#### **Addendum 33 – UN Regulation No. 34**

#### **Revision 2 - Amendment 7**

04 series of amendments – Date of entry into force: 5 June 2023

#### **Uniform provisions concerning the approval of vehicles with regard to the prevention of fire risks**

Model A

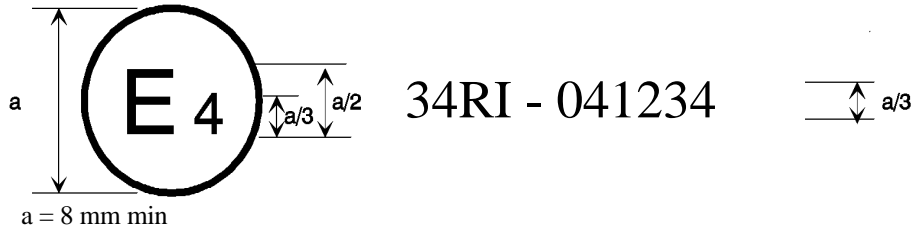
*Annex 2*, amend to read (footnote unchanged):

The above approval mark affixed to a vehicle shows that the type concerned was approved in the Netherlands (E4) pursuant to Part I of UN Regulation No. 34 under approval No. 041234. The first two digits (04) of the approval number indicate that the approval was granted in accordance with the requirements of UN Regulation No. 34 as amended by the 04 series of amendments."

Model C

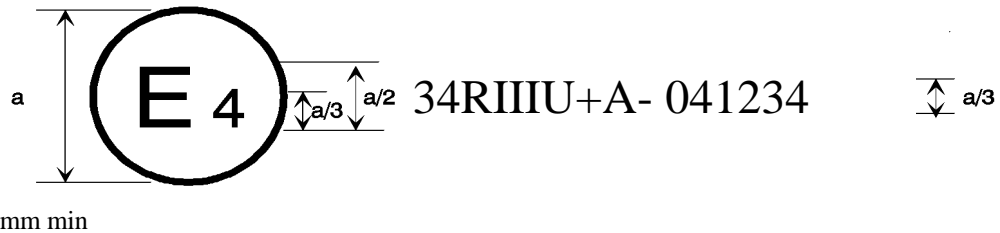
The above approval mark affixed to a fuel tank shows that the type concerned was approved in the Netherlands (E4) pursuant to Part III of UN Regulation No. 34, for a universal use including its accessories, under approval No. 041234. The first two digits (04) of the approval number indicate that the approval was granted in accordance with the requirements of UN Regulation No. 34 as amended by the 04 series of amendments.

Model E

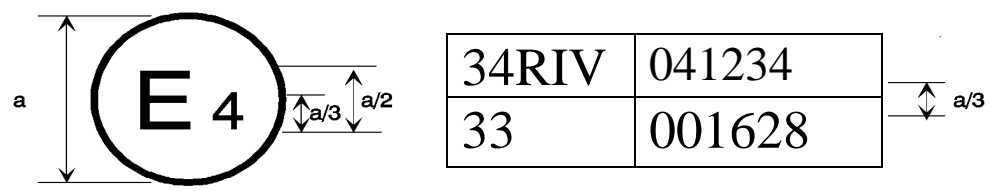
The above approval mark affixed to a vehicle shows that the type concerned was approved in the Netherlands (E4) pursuant to UN Regulations Nos. 34 Part IV and 33.\* The approval numbers indicated that, at the date when the respective approvals were given, UN Regulation No. 34 included the 04 series of amendments and UN Regulation No. 33 was still in its original form."
